Architectural Review Committee

AGENDA - AMENDED

TOWN OF BROOKFIELD ARCHITECTURAL REVIEW COMMITTEE STAFF REPORT

RE: ARC Staff Report – January Agenda Items

werfen

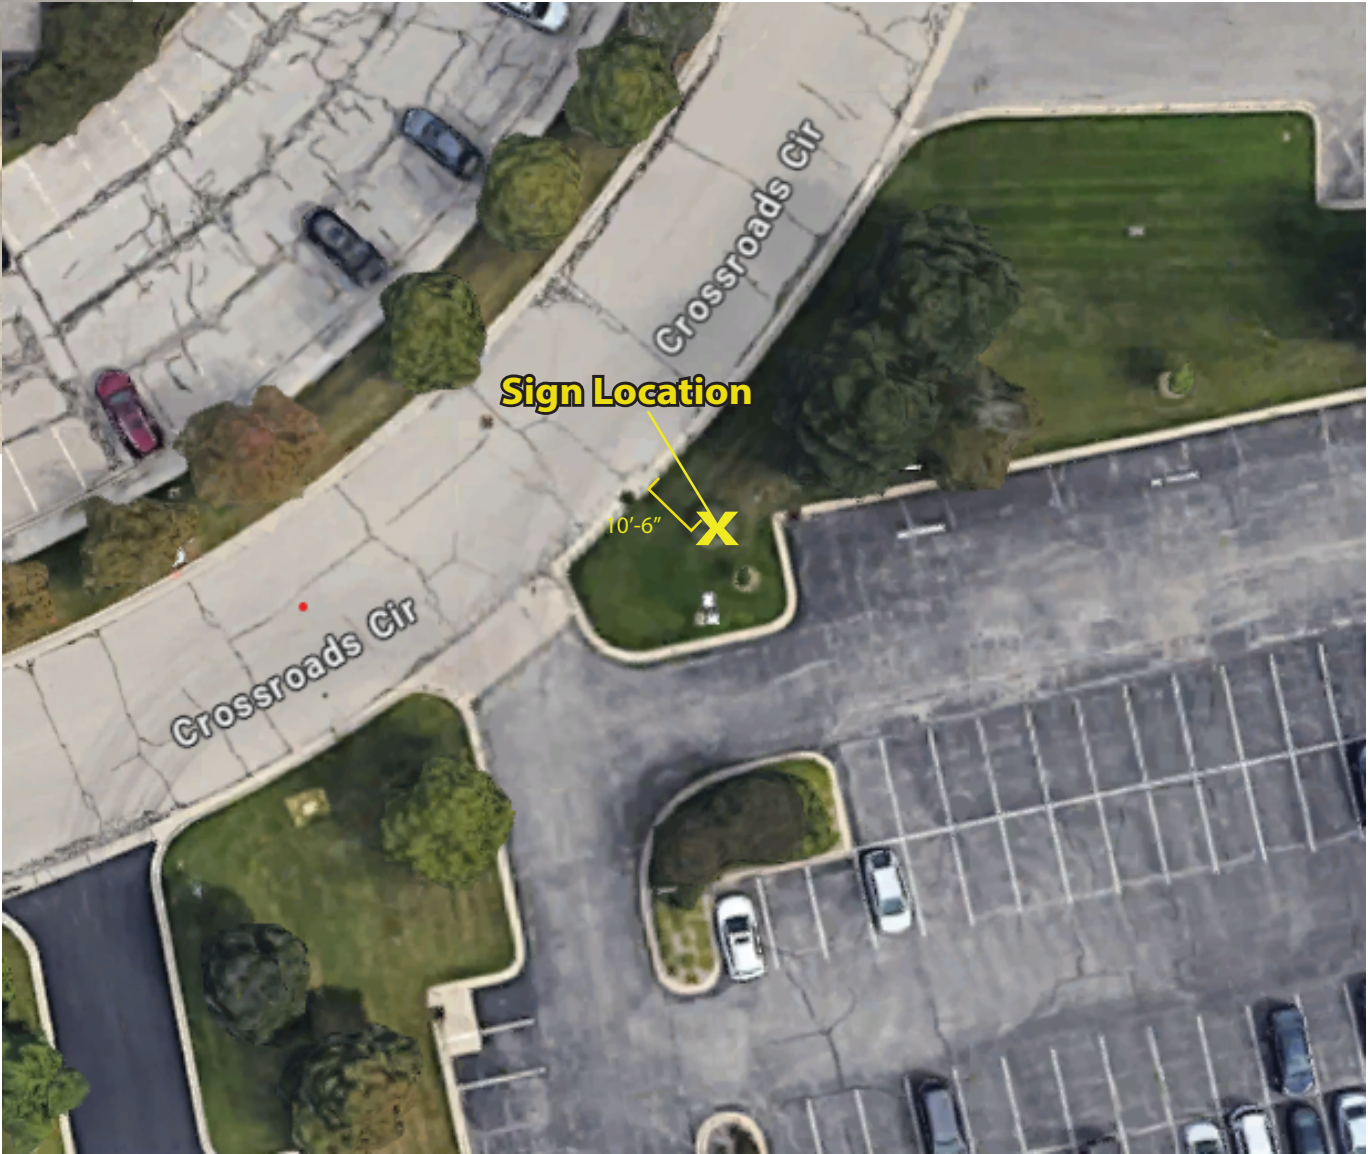
- Sign is proposed to be 4.6' from grade and has two panels showing the property address and the Werfen logo.
 - Both panels are approximately 27.6 square feet each (55.2 square feet total).

- The majority of the sign structure is blue and the lettering is white.
- The signs will be internally illuminated.
- No dimensions were provided for the address numerals. The typical requirement is a minimum of 8 inches.

Sign Location & Set Back

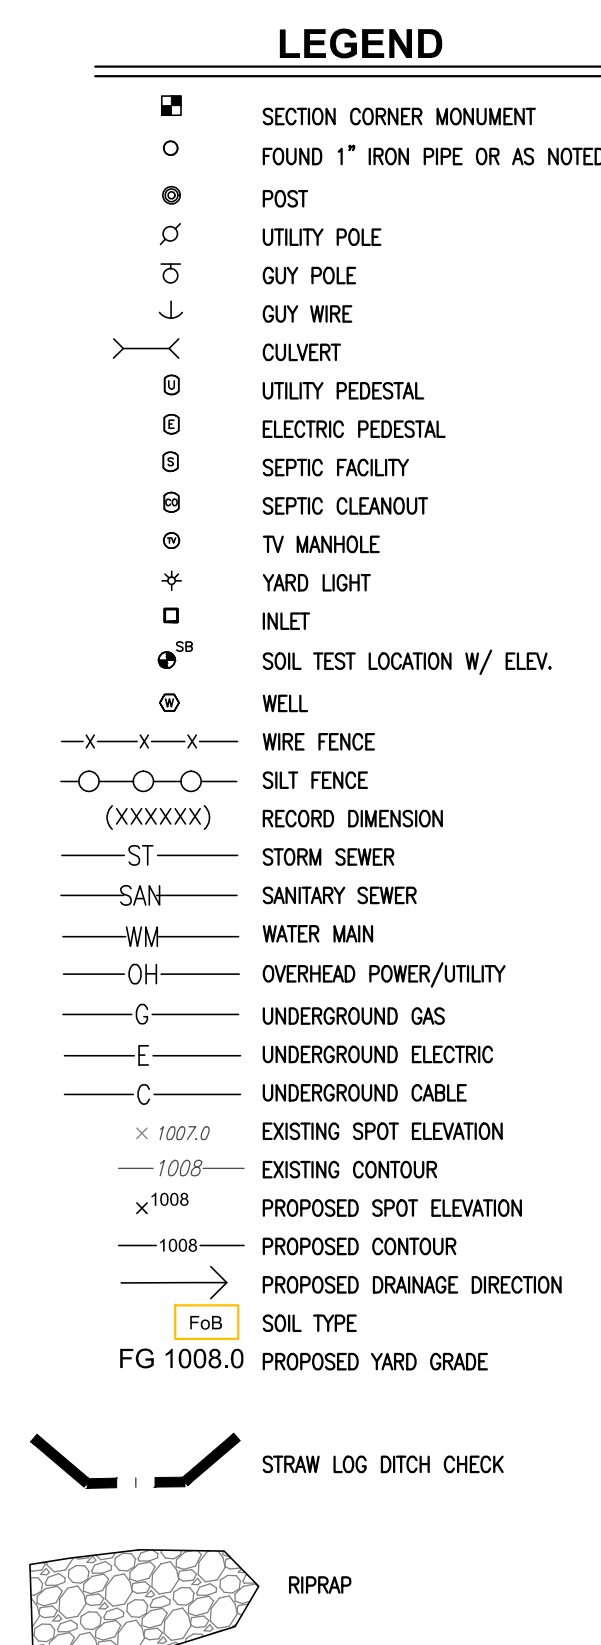
- Proposing to add a freestanding sign near the entrance of the parking lot. The site plan in the packet shows the proposed sign being located on the property line where the existing sign is currently located. The sign will need to meet the 5' setback and/or receive a variance. The applicant has stated that they will likely request a variance. If the Committee decides to approve this sign, a condition should be applied to require that the sign either meets the 5' setback requirement or a variance is granted.

SITE PLAN

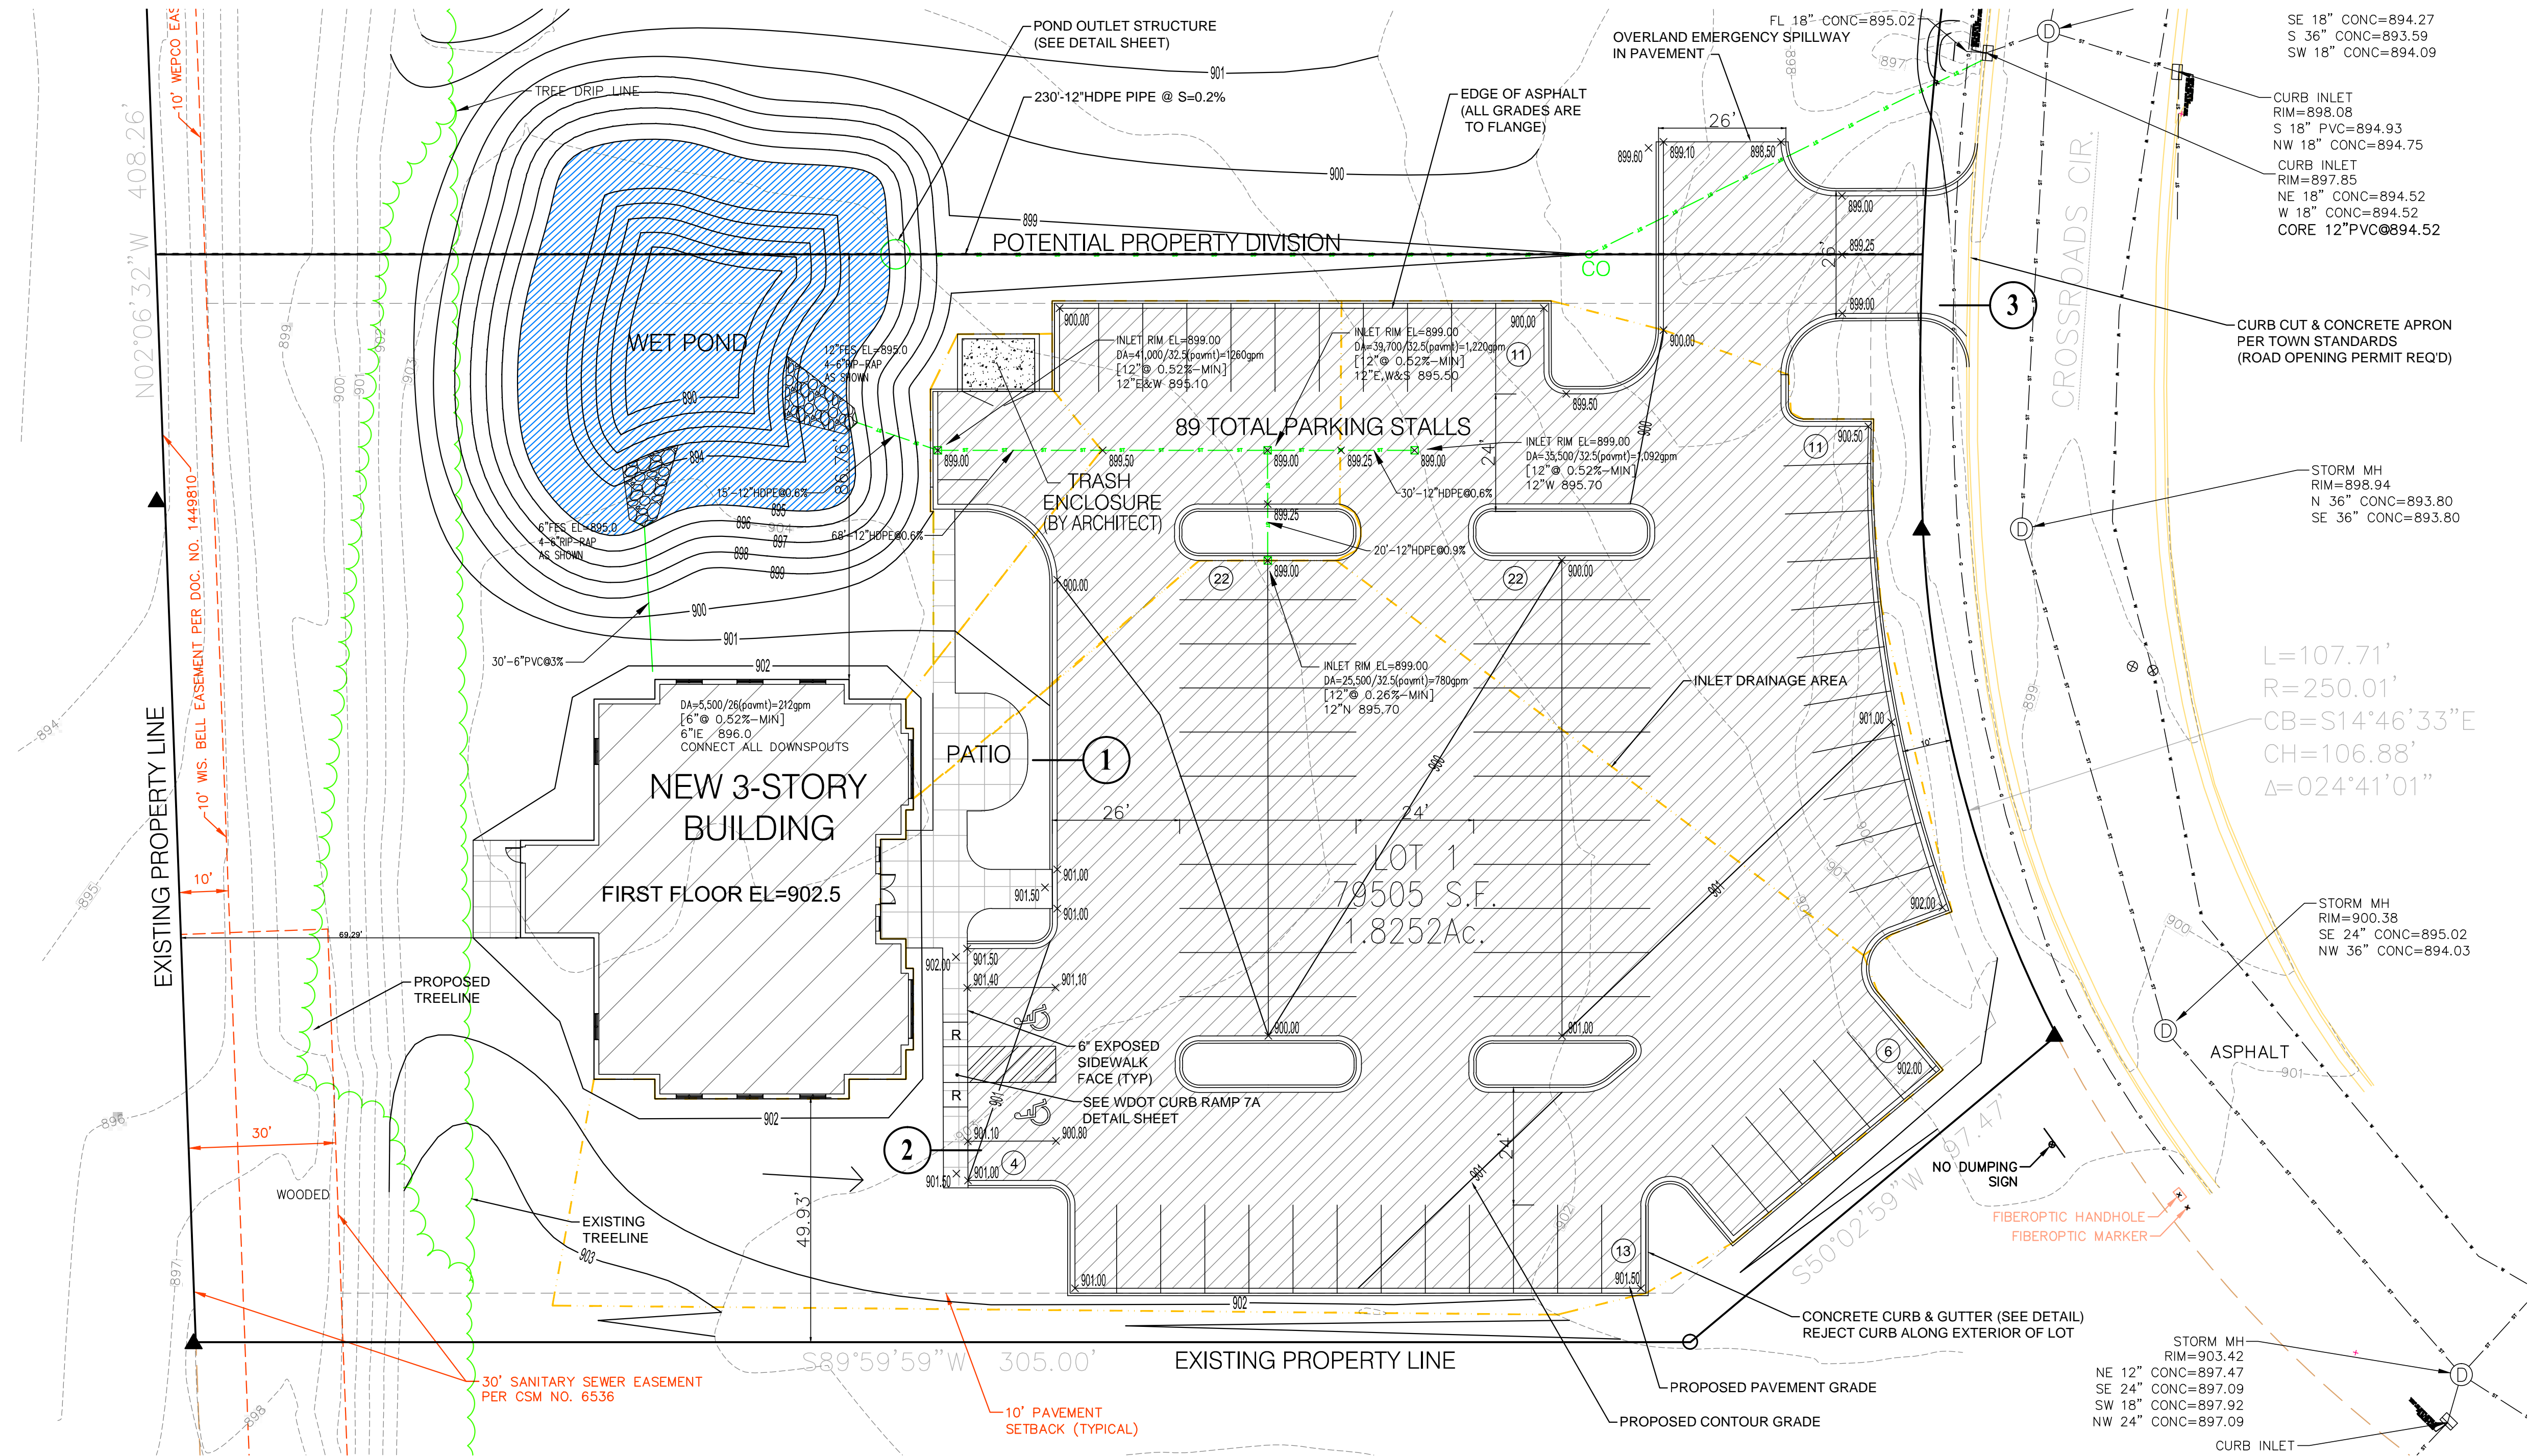
- The applicant is proposing to add a stormwater pond to the north of the building and this is proposed to serve the potential northern lot as well.
- Note: Some of the site data provided on the site plan (Sheet C100) is inaccurate as the total floor area and the floor area ratio.
